Bodangora Wind Farm (MP 10_0157) - Minor Modification relating to micrositing

Ahead of providing confirmation on the final layout co-ordinates, we wanted to followup on our discussion to outline three minor changes outside of the current micro-siting limitation of 100 metres (m). We understand from subsequent discussions that this will require a minor modification from the Department. Please consider this letter as Bodangora Wind Farm Pty Ltd's (BWF) request for the minor modification.

Fig.1. Extract of layout showing track (red line) diverging out of the 100m yellow corridor to avoid the native vegetation (solid green area).

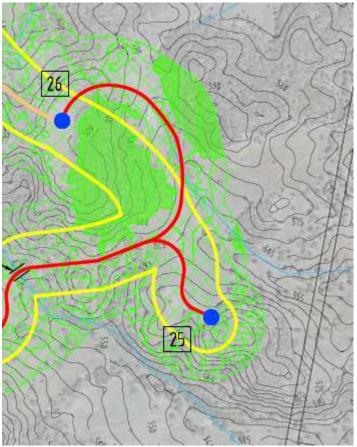
BWF is requesting to diverge out of the 100m micro-siting limit of the track connecting turbine 25 and 26. The change is to allow the revised track alignment to avoid the native vegetation. This is shown on Figure 1 below

Under Condition E.21(f) BWF is required to minimise its impact on native vegetation. Following the base line vegetation mapping exercise which was inserted as a condition during Modification 2, as shown in Fig 1, it was identified that there was a section of vegetation that was classified as native vegetation. Within the 100m limitation it was not possible to avoid this cluster of vegetation without going outside of the 100m buffer. In keeping with the principle of minimizing native vegetation clearing we are proposing to reroute the track outside of the currently approved corridor by around 50m in the worst case which will minimise the removal of approximately 0.192ha of native vegetation.

Fig.3. Aerial image showing approved and proposed turbine location for turbine 31

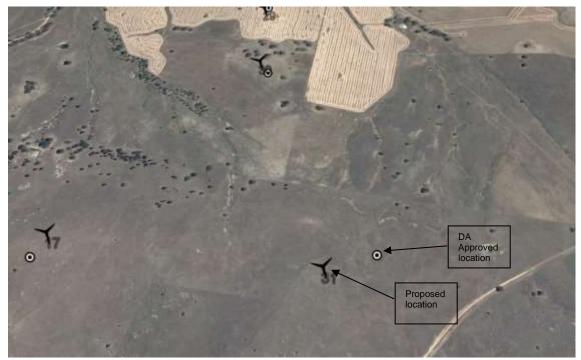
BWF is seeking to shift wind turbine #31 to the west of the approved location by an additional 72m than is currently permitted under the approved development application. The revised co-ordinates are shown below and an aerial image is also included.

The primary reason for this proposed shift is due to terrain and access. With the more onerous conditions relating to the crossing of the Sandy Hollow Railway corridor, we are now required to have a formal crossing approved by Transport NSW. To reduce the amount of access track and to ensure the track is perpendicular with the crossing it is of benefit to shift the turbine location further west. The revised location is also at a slightly higher elevation which improves the yield of the turbine and shortens the distance of the tracks between turbines.
